To: Development Permit Panel
From: Joe Erceg
Manager, Development Applications
Date: July 25, 2002
File: DP 01-198040
Re: **Application by Perkins & Company Architecture and Urban Design Inc. for a
Development Permit at 4388 Moncton Street**

Staff Report

DP 01-198040 SCHEDULE "A"

IMPERIAL LANDING AT STEVESTON - Parcel F5

PARCEL F5 ELEVATIONS & SECTION	
PROJECT NO.	2198
TOWN	IMPERIAL
DATE	NOV 26 2002
SCALE	1/8" = 1'-0"
DRAWING NO.	4

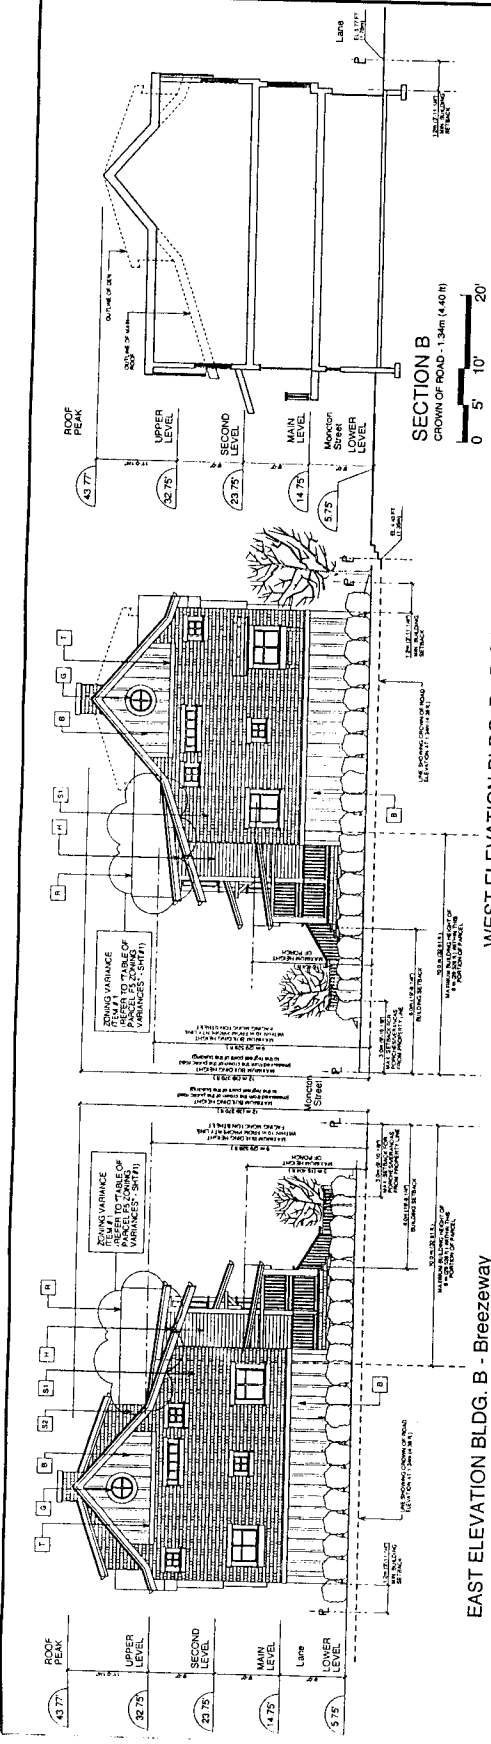
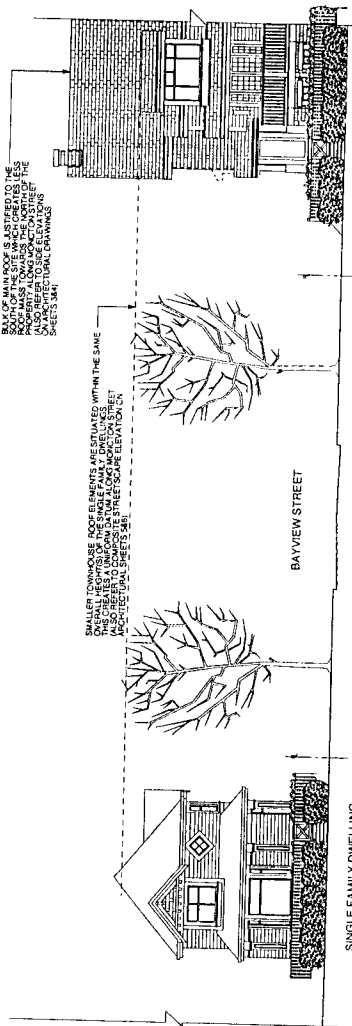
B. The applicant has reduced the extent of one (1) previously requested height variance for DP 01-198040 as follows. The applicant requests that the previously requested variance:

1. The projection of the roofline for three (3) gable ends to a maximum of **2.057 m (6.75 ft.)** above the 9.0 m (29.528 ft.) maximum building height within 10.0 m (32.808 ft.) from the property line abutting Moncton Street;

1. The projection of the roofline for three (3) gable ends to a maximum of **1.091 m (3.579 ft.)** above the 9.0 m (29.528 ft.) maximum building height within 10.0 m (32.808 ft.) from the property line abutting Moncton Street;

2. The currently requested height variance to Comprehensive Development District (CD/101) regarding DP 01-198040 at 4388 Moncton Street related to related to three (3) gable ends along Moncton Street on Building 'B' are similar to the height variances recently approved for the newly constructed single family residential dwellings related to Comprehensive Development District (CD/102) as part of Development Variance Permit DVP 01-197537. DVP 01-197537 was reviewed by the Development Permit Panel on January 30, 2002 and approved by Council on February 11, 2002. Development Permit Application DP 01-198040 for 4388 Moncton Street requests 1 height variance related to the projection of three (3) gable ends along Moncton Street. The height variance for three (3) gable roof ends is supported because they add character to the exterior elevations. The requested variance that would reduced the amount of private outdoor space and the variance to permit tandem parking are identical to variances recently approved by Council at a Public Hearing on July 15, 2002 regarding DP 01-198040 for Imperial Landing Development Parcel 'F4' located at 4311 Bayview Street. Staff support the requested variances for this development permit application.

It is the staff evaluation that the requested height variance to Comprehensive Development District (CD/101) as part of Development Permit Application DP 010-198040 will add character to the street façade of Building 'B' along Moncton Street. With regard to the requested variances to reduce the private outdoor space and permit tandem parking, there are identical and recently approved variances for DP 01-198040 for Imperial Landing Development Parcel 'F4' located at 4311 Bayview Street. Therefore, staff supports the requested variances and recommends approval of DP 01-918040.

LANDSCAPE PLAN

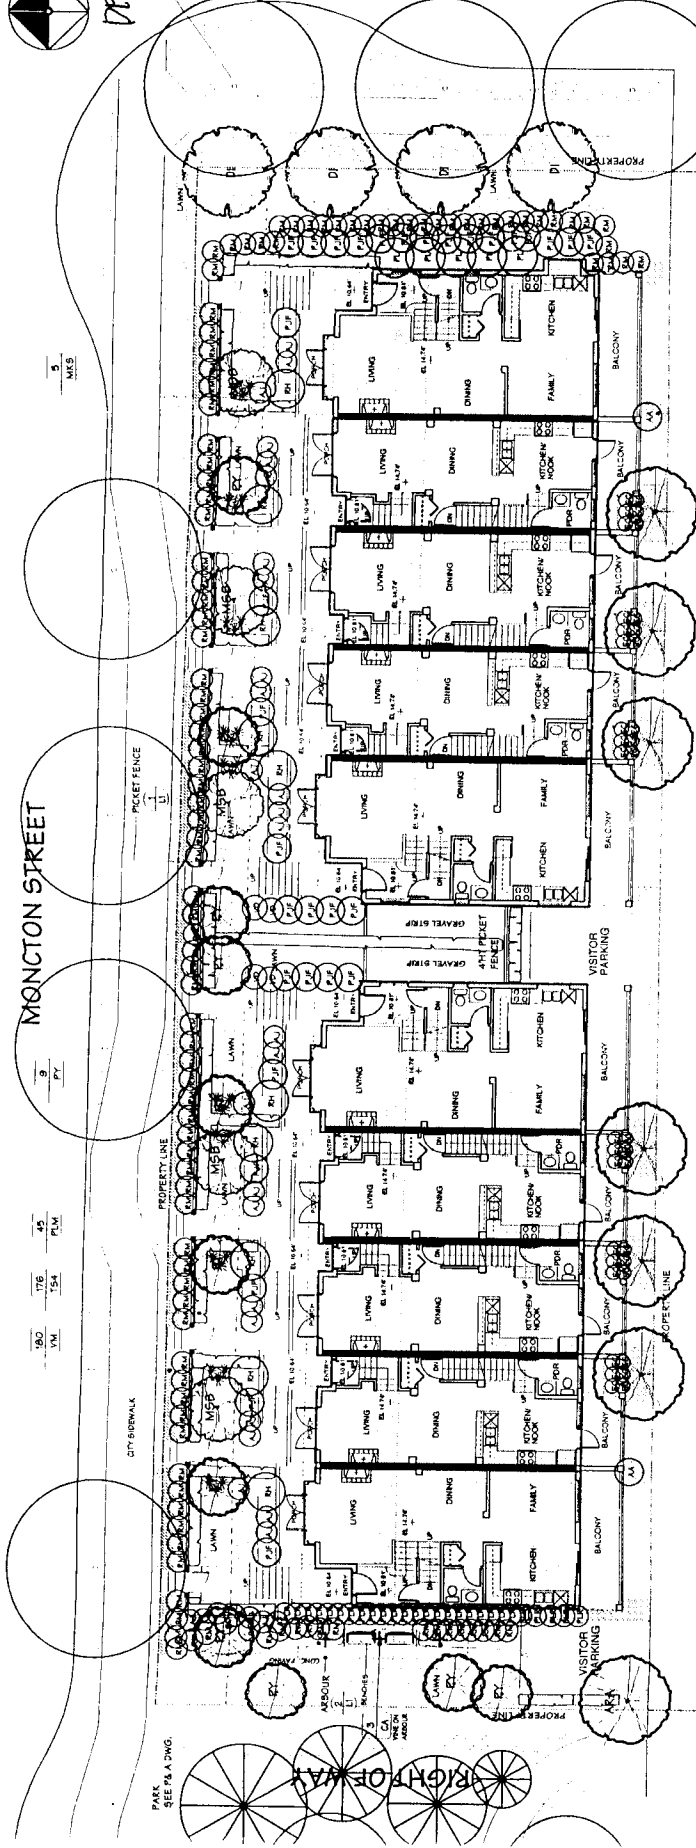
2. Relocate the visitor parking stall along Bayview Street into the space between the two (2) blocks of townhouses along the lane and increase the landscape planting along the street. *Visitor parking will remain in the same location along Bayview Street however the stall has been moved closer to Building A to allow for more planting along the street as requested by the planning department. The space between the two townhouse buildings will remain as a landscaped area, which is much more desirable (refer to Parcel 'F5' site plan sheet and elevation sheets).*

4. Eliminate the fencing and hedging that separates the landscape side yard from the Bayview Street boulevard. Create a semi-public space in this location along the street and propose a landscape treatment that is more transparent and visually accessible from the sidewalk. Consider foundation planting at the base of the building rather than perimeter planting. In addition, provide benches and a trellis structure similar to the treatment along the west property line. *The landscape consultant has eliminated the fencing and hedging that separates the side yard from Bayview Street and has created a more transparent and visually accessible space as requested by City of Richmond staff.*

CLIENT TITLE
**PARCEL F5
ELEVATIONS & SECTION**

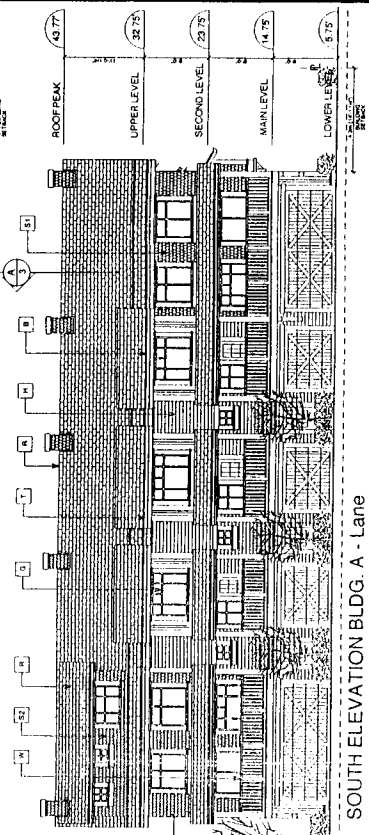
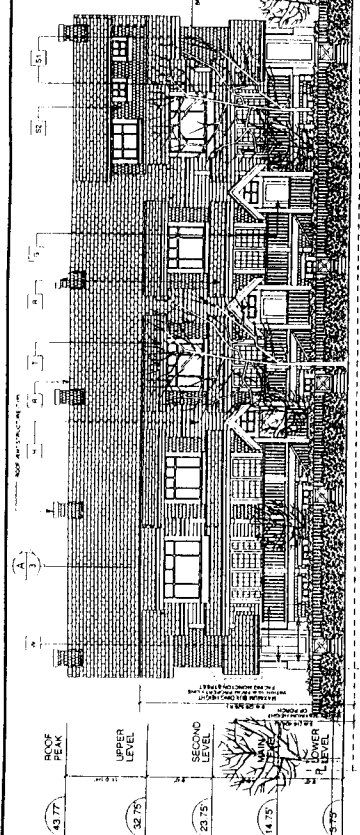
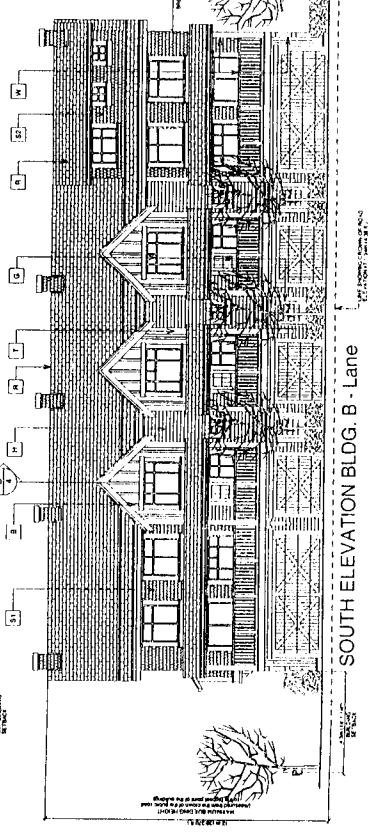
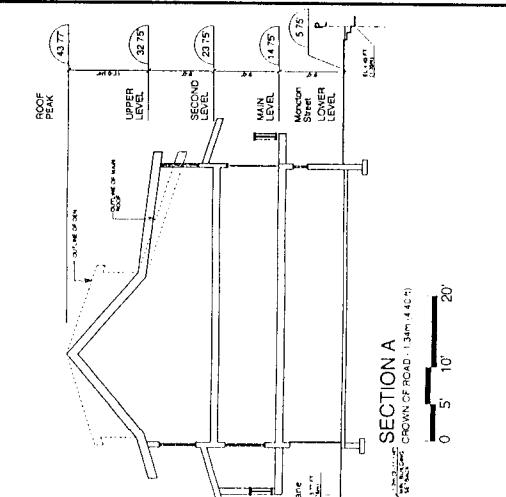
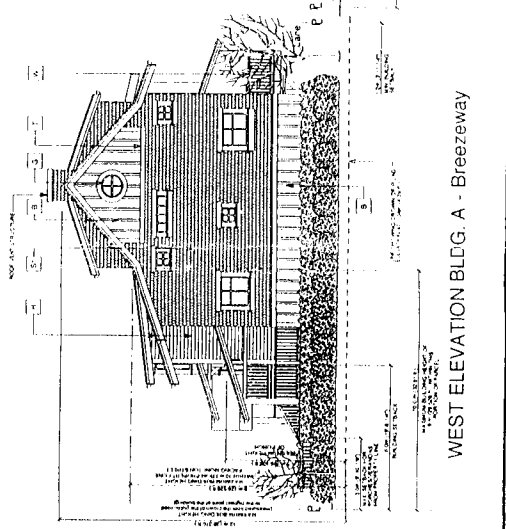
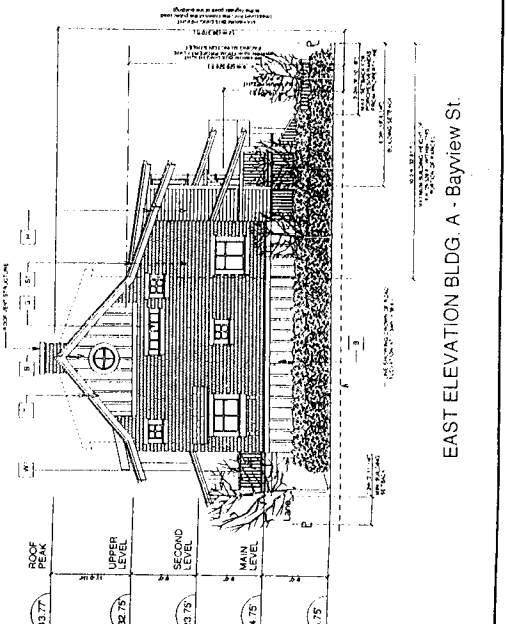
3. Consider changes to the massing of the proposed built form, which creates a more friendly transition from this townhouse parcel to the small lot single-family residential area across Bayview Street (i.e. to the east). For example, consider stepping down the roof and the building massing along the east property line adjacent to Bayview Street or consider transposing the locations of Buildings A and B. Retain the upper level dens in the present location and consider the relocating the high dormer closer to the west property line. Provide a section across Bayview Street to help assess this issue. *Locations of Building A and B have been transposed thereby relocating the high dormer closer to the west property line. The bulk of the main roof is justified towards the south portion of the site thereby reducing the massing at the north of the site along Moncton Street. The smaller roof elements line up with the maximum roof heights of the single-family dwellings thereby creating a continuous datum along Moncton Street (refer to Parcel 'F5' elevation sheets).*

4. Identify the location of building Section 'A'. *Section A has been identified on the elevations and plans (refer to Parcel 'F5' site plan and elevation sheets).*

6. Clarify the lower level cladding material and colour for the side elevations (i.e. board and batten wood siding?) *The lower level cladding material is board and batten (refer to Parcel 'F5' elevation sheets).*

9. Substitute the sliding glass doors along Moncton Street with double 'French' doors. *All sliding glass doors along Moncton Street have been replaced with double French doors (refer to Parcel 'F5' site plan and elevation sheets).*
